**Highland Park Remembrance
2037 McGee Side Road
Servicing and Stormwater Management Report**

**Reference: Highland Park Remembrance 2037 McGee Side Road
Servicing and Stormwater Management Report
City File No.: D07-12-19-0112
Our File No.: 101063**

Subject: Site Plan Control Application – 2037 McGee Side Road - 1st Review Comments

Reference: 2037 McGee Side Road – Site Plan Control Application
Response to Comments – 1st Review
City File No.: D07-12-19-0112
Our File No.: 101063

LOCATION	
2037 McGEE SIDE ROAD, CITY OF OTTAWA HIGHLAND PARK REMEMBRANCE	
DRAWING NAME	PROJECT No.
	101063
	REV
GRADING AND SERVICING PLAN	REV # 4
	DRAWING No.
	101063-GR

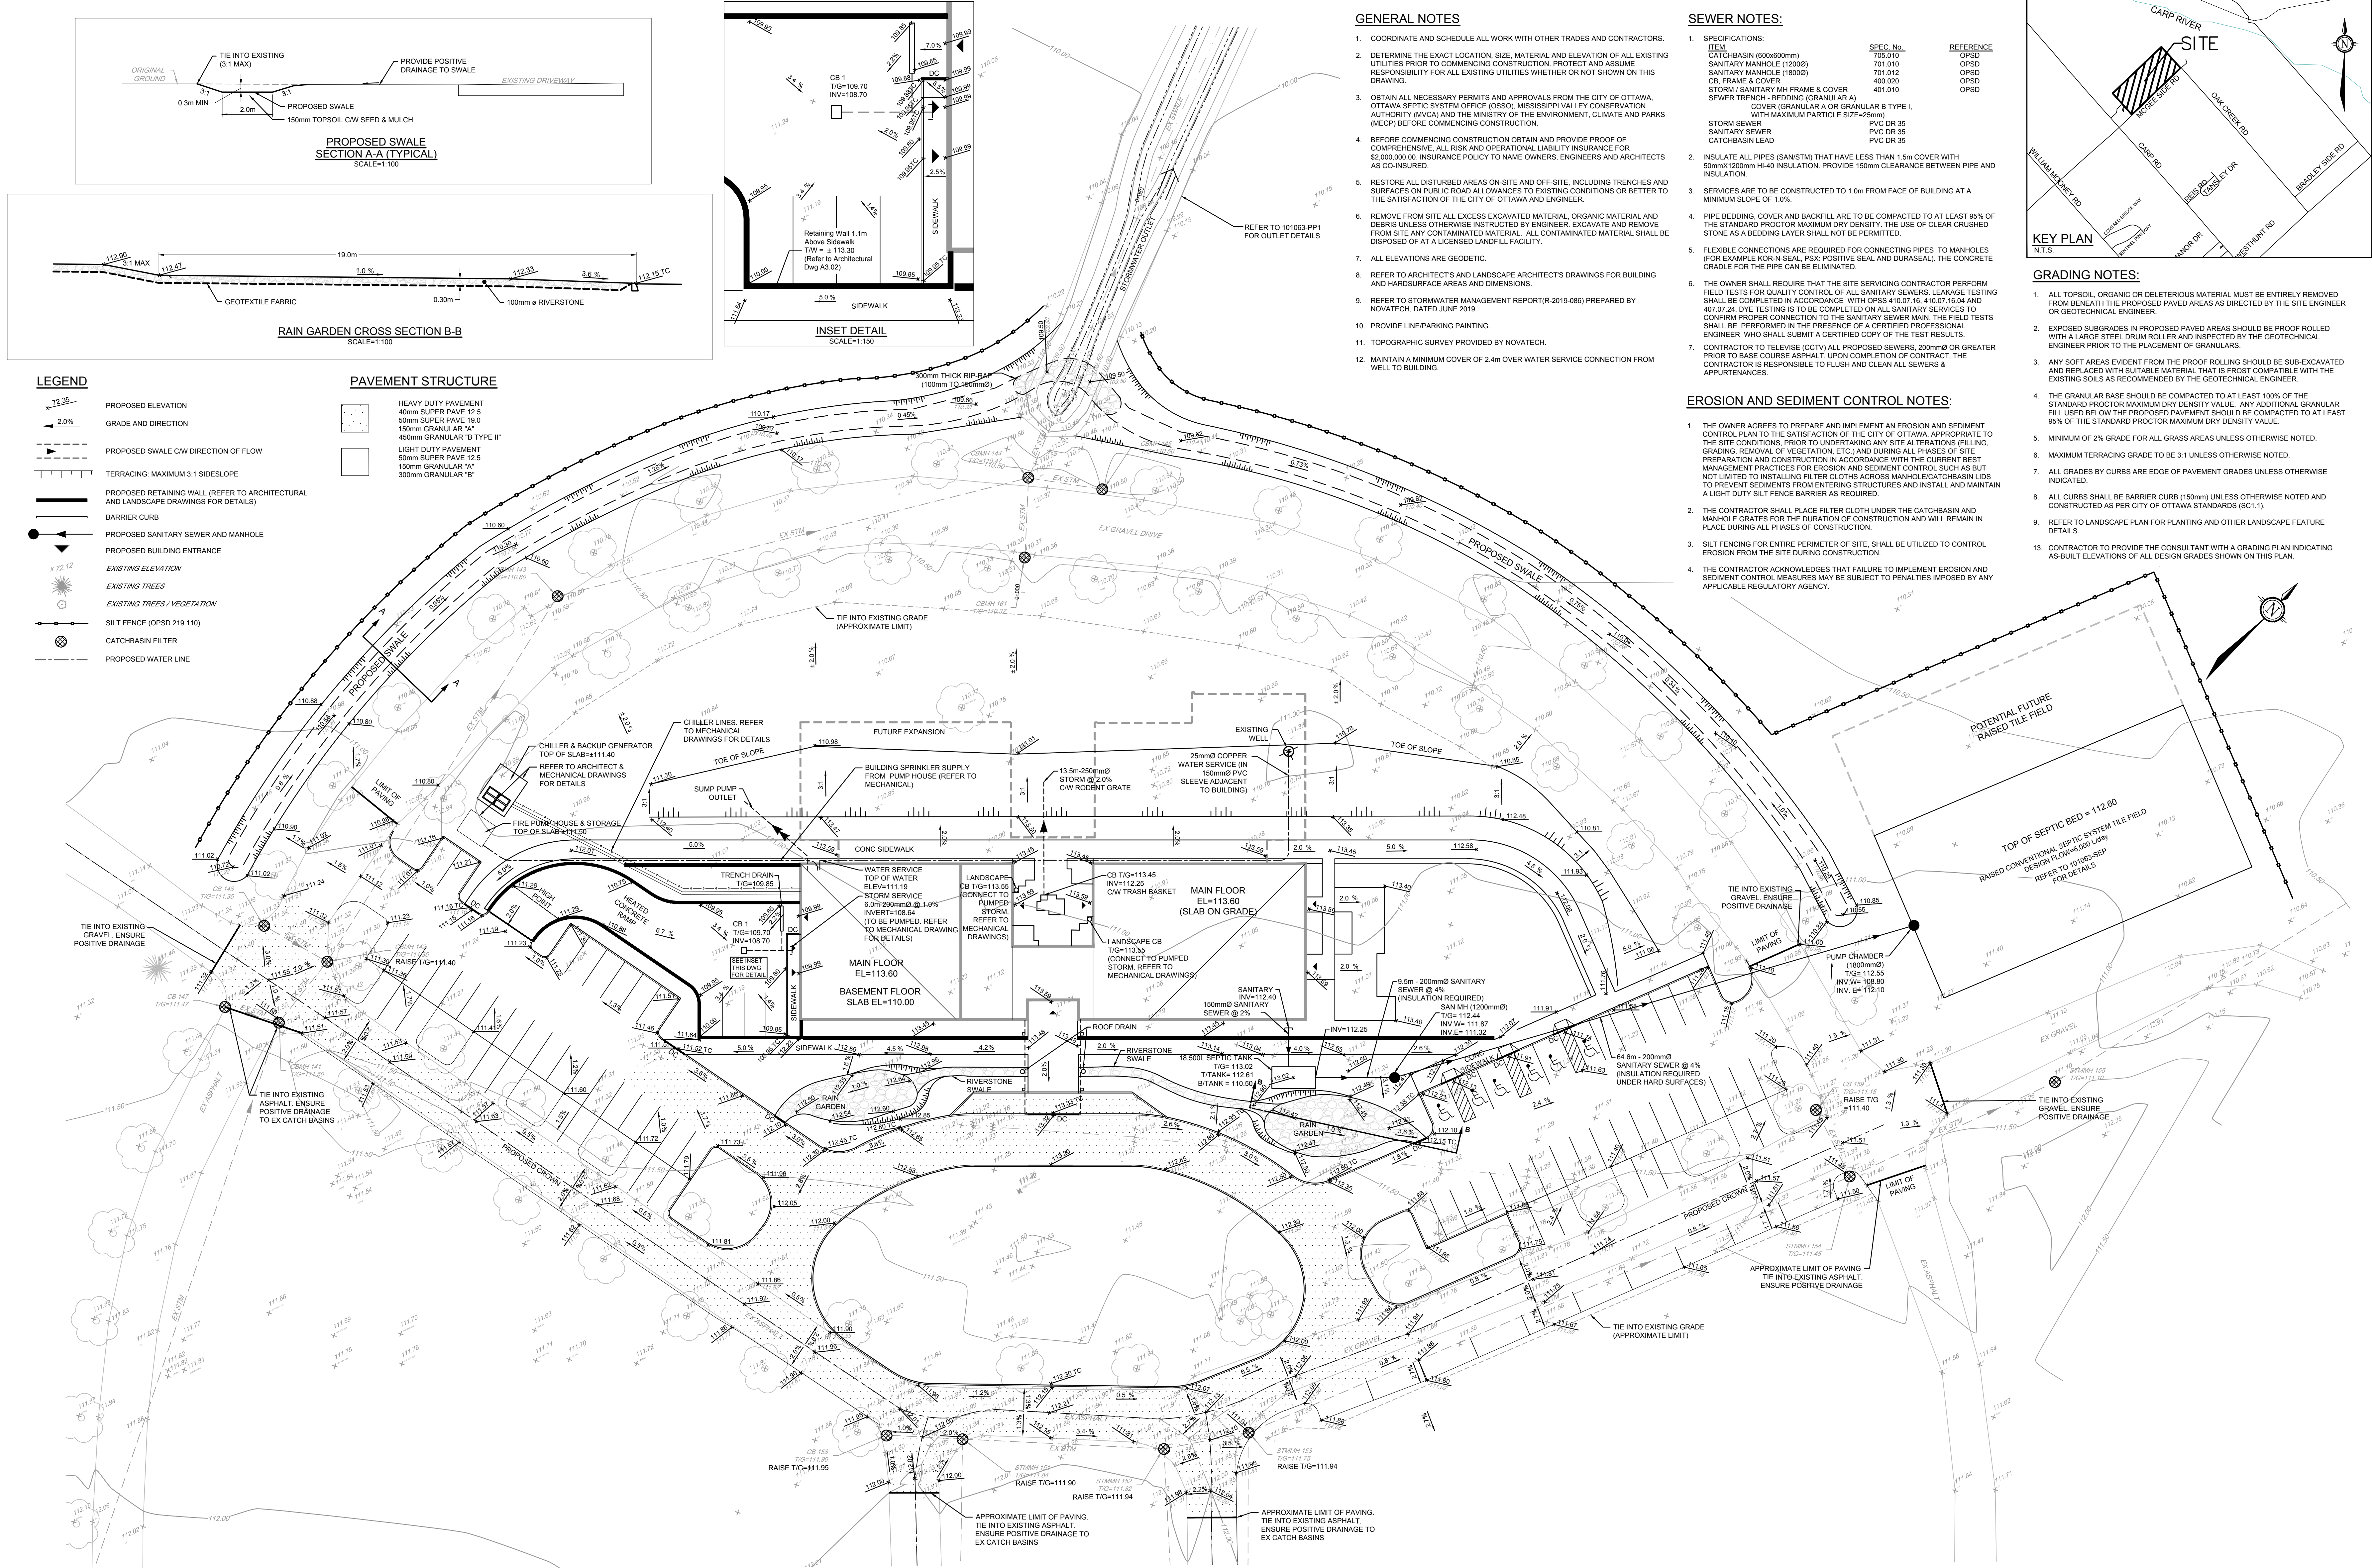
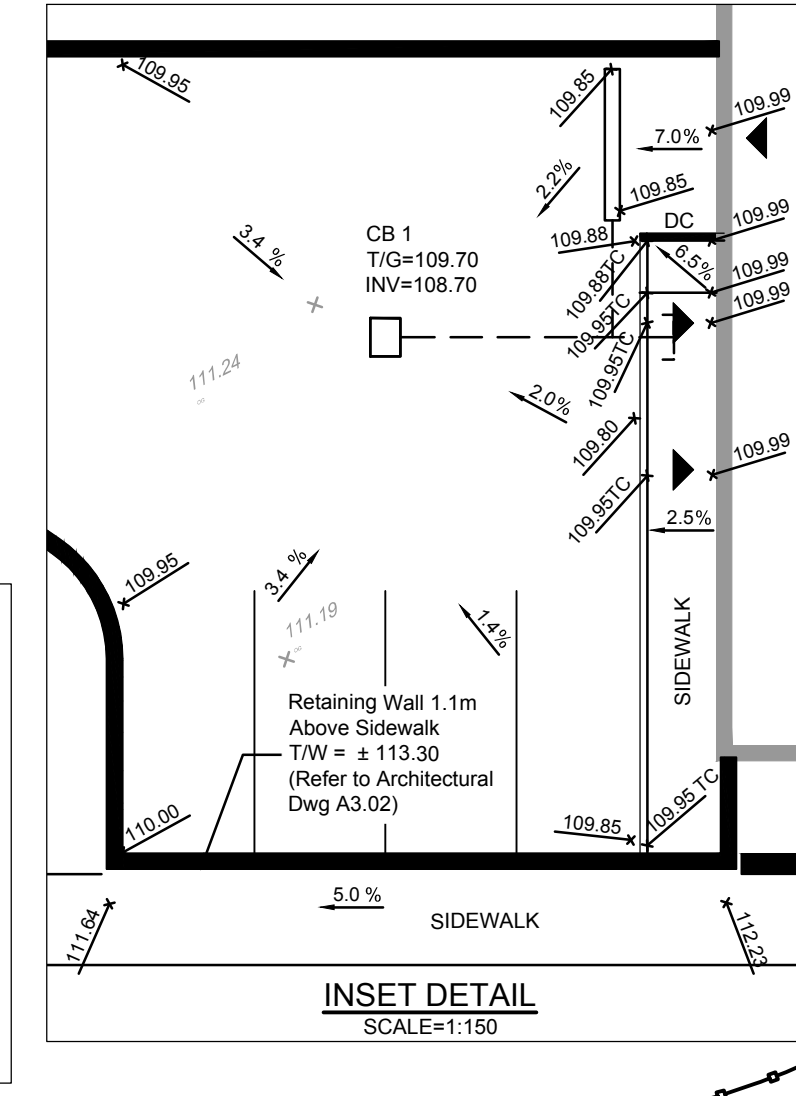
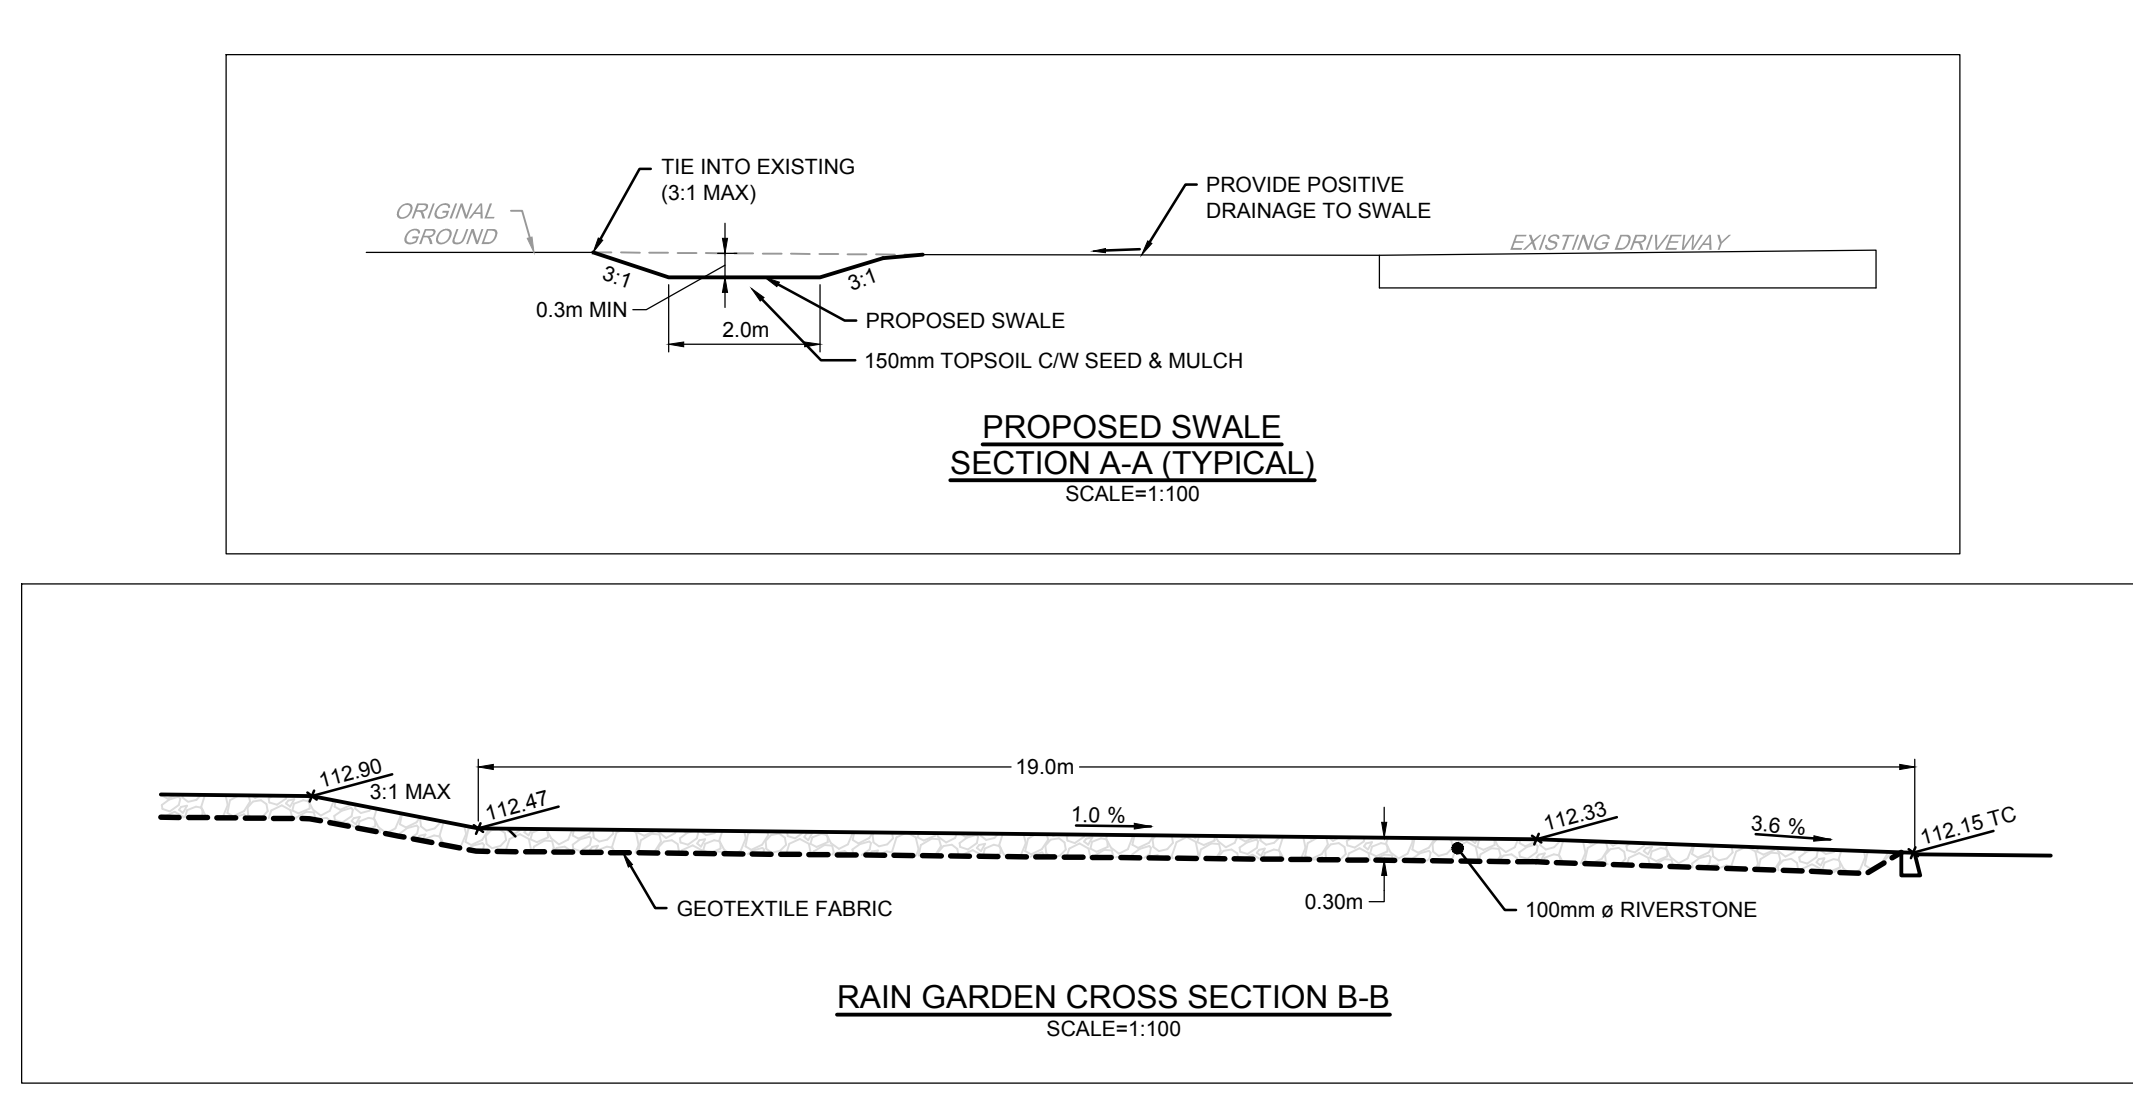
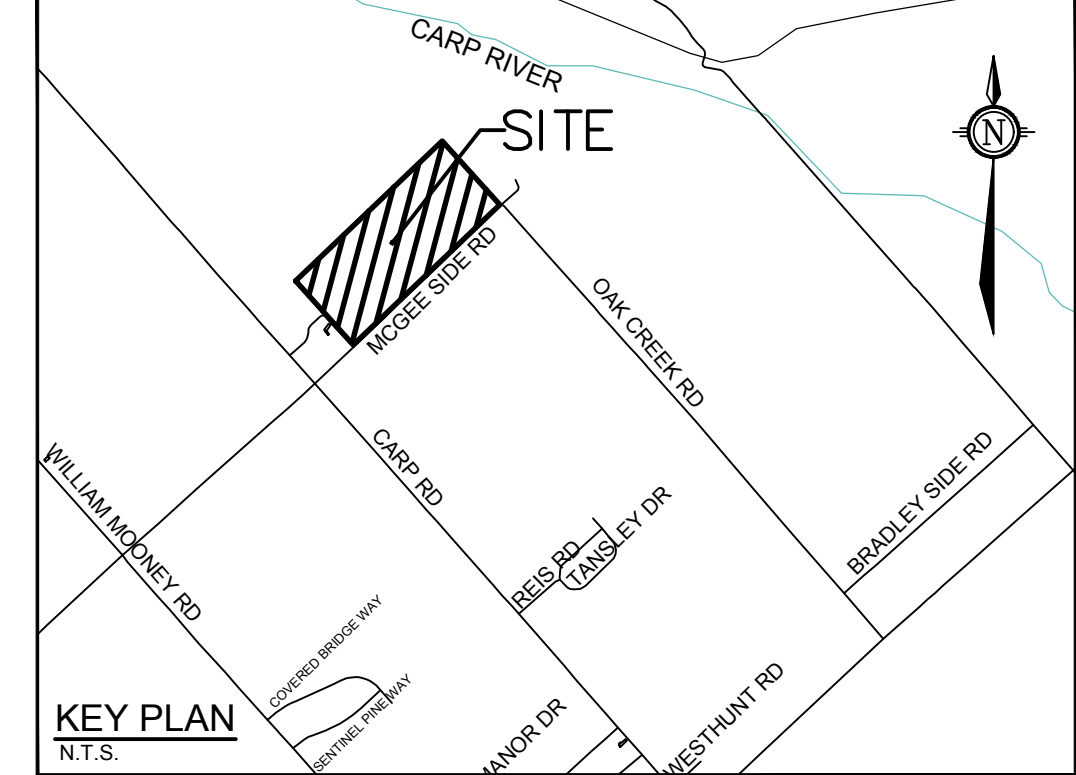
- 1.1. There does not appear to be enough cover over the water service from the well.
- 1.2. Provide clarification on the grades in the area of the sidewalk and the bottom of the loading ramp. There is quite a drop from the parking lot sidewalk to the parking stalls at the bottom of the ramp. Should some kind of railing be installed?
- 1.3. Provide grades and slop % on the sidewalk going down to the basement garage entrance.
- 1.4. The pavement structure detail does not match the reports

- 1.2 *Provide clarification on the grades in the area of the sidewalk and the bottom of the loading ramp. There is quite a drop from the parking lot sidewalk to the parking stalls at the bottom of the ramp. Should some kind of railing be installed?*

- 1.3 *Provide grades and slope % on the sidewalk going down to the basement garage entrance.*

- 1.4 *The pavement structure detail does not match the reports.*

Novatech Response: General Note 12 has been added to indicate that a minimum cover of 2.4m must be maintained above the water service line from the well to the building.

Novatech Response: Inset detail has been added to Drawing No. 101063-GR to provide clarification. The wall extends above the grade of the parking lot sidewalk. Please refer to Architectural Drawing 1/A3.02 West Elevation – Section O/S Receiving.

Novatech Response: As noted above, inset detail has been added to Drawing No. 101063-GR to provide clarification.

Novatech Response: Pavement Structure detail in Drawing No. 101063-GR (rev3) has been revised to match the reports.
